SUNOCO ENERGY DEVELOPMENT COMPANY
SAGE POINT-DUGOUT CANYON MINE

Application for SMCRA Permit Approval and Mining Plan

OSM
FINDINGS
SUNOCO ENERGY DEVELOPMENT COMPANY
SAGE POINT-DUGOUT CANYON MINE

Application for SMCRA Permit and Mining Plan Approval

Map 2 - Dugout Creek Raptor
Nest Sites

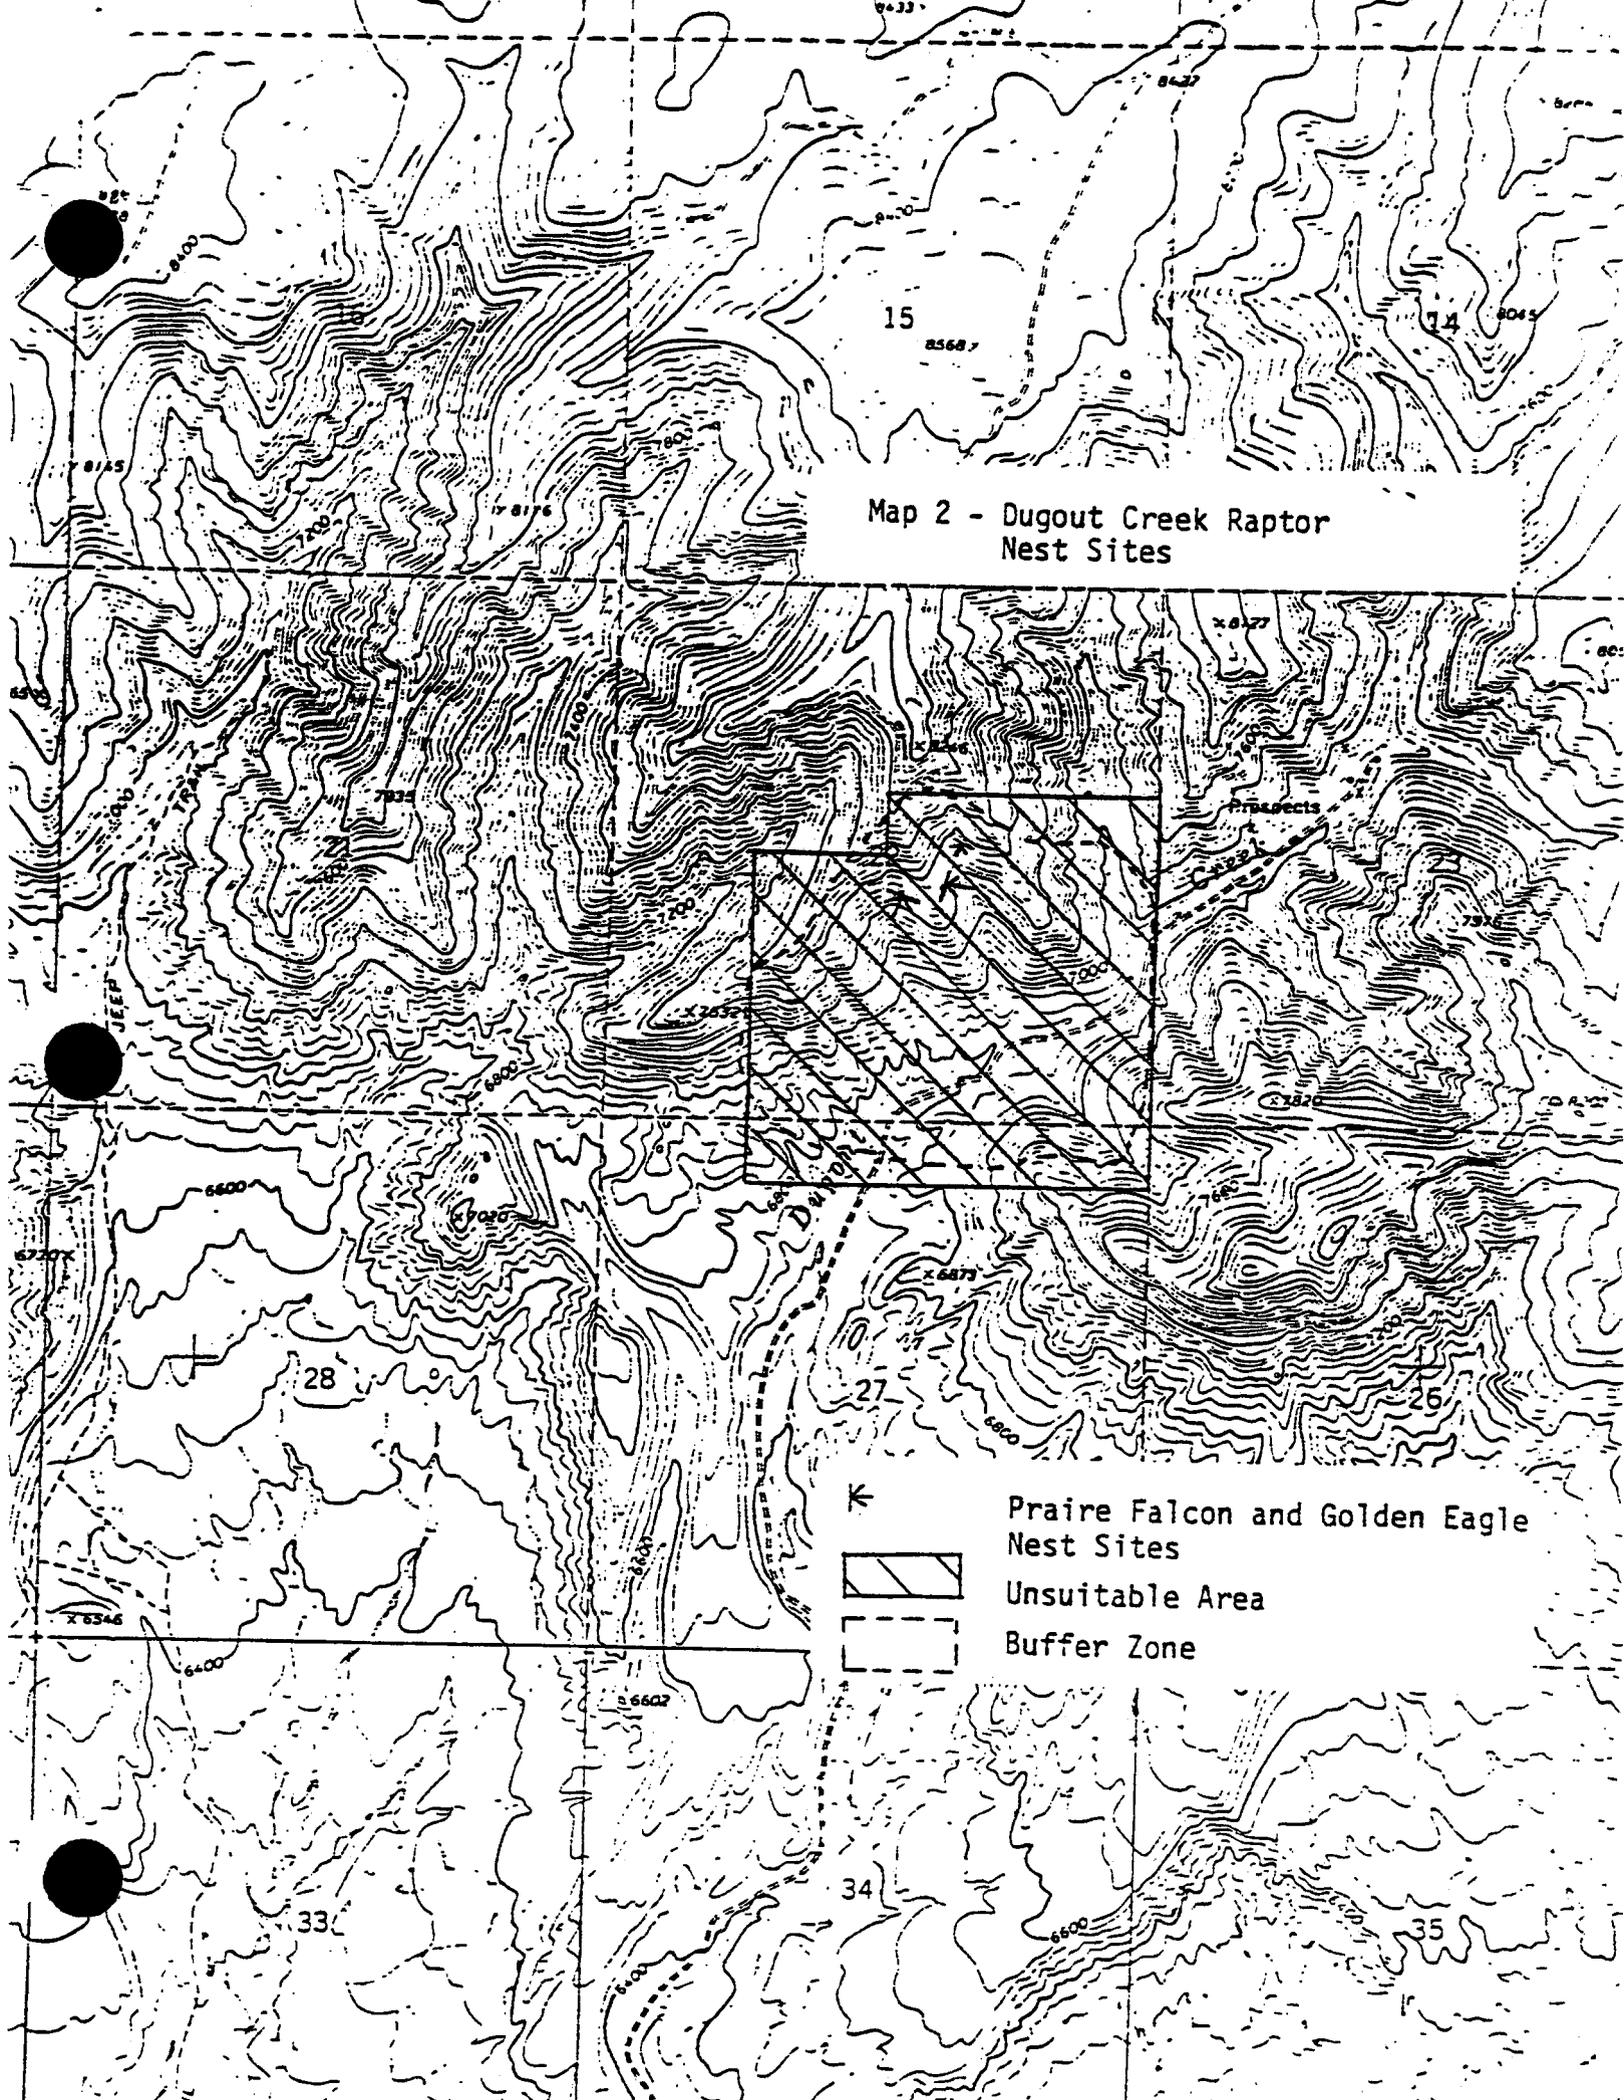
Change 3 - Rewrite second sentence: "A buffer zone, delineated on map 2, has been established for protection of these sites within which the following mitigating measures apply:"

Figure 4. Raptor Nest Buffer Zones

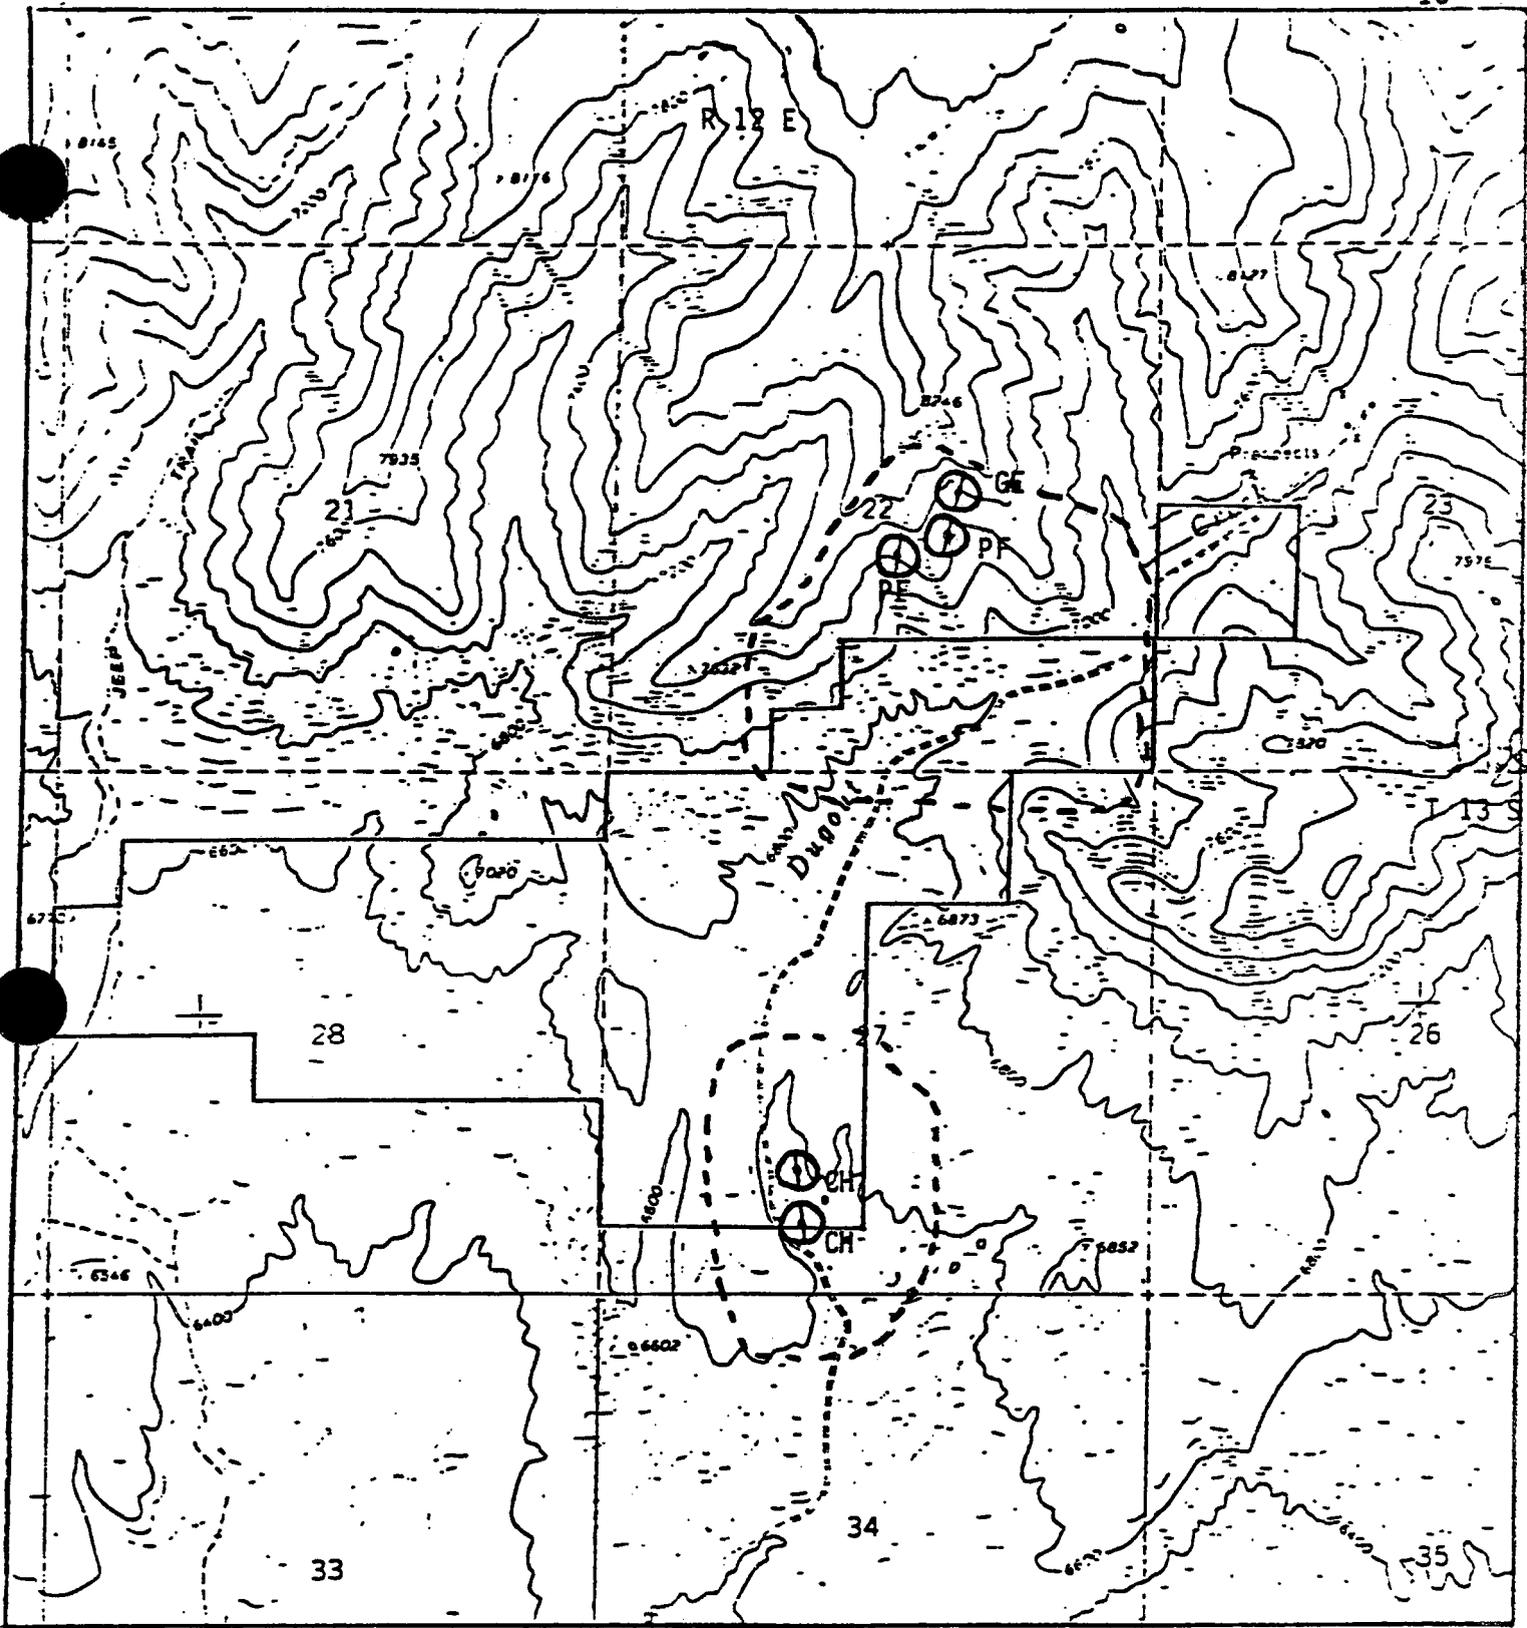
Q. Two Cooper's hawk nests have been documented as active by the BLM and the UDWR. A buffer zone established for the protection of these nest sites is outlined on Figure 4 (attached) and is unsuitable under Criterion 13. An exception can be applied with the following stipulations:

R. One active prairie falcon eyrie, one suspected prairie falcon eyrie and one golden eagle nest site (old) were documented by the FWS and the UDWR. A buffer zone delineated on Figure 4 identifies the area considered unsuitable according to Criteria 11 and 13 of the Unsuitability Criteria. An exception can be applied to allow limited surface disturbance based on the following stipulations:

- 1. Surface construction activities may be prohibited within the buffer zone (Figure 4) during the critical nesting period, March 15 to June 15. Surface construction may be initiated on June 1 if a nesting attempt has not been documented by the lessor in consultation with the FWS. Surface construction may also be initiated on June 1 if a determination by the lessor, in consultation with the FWS, shows the nesting attempt to be nonproductive. This determination
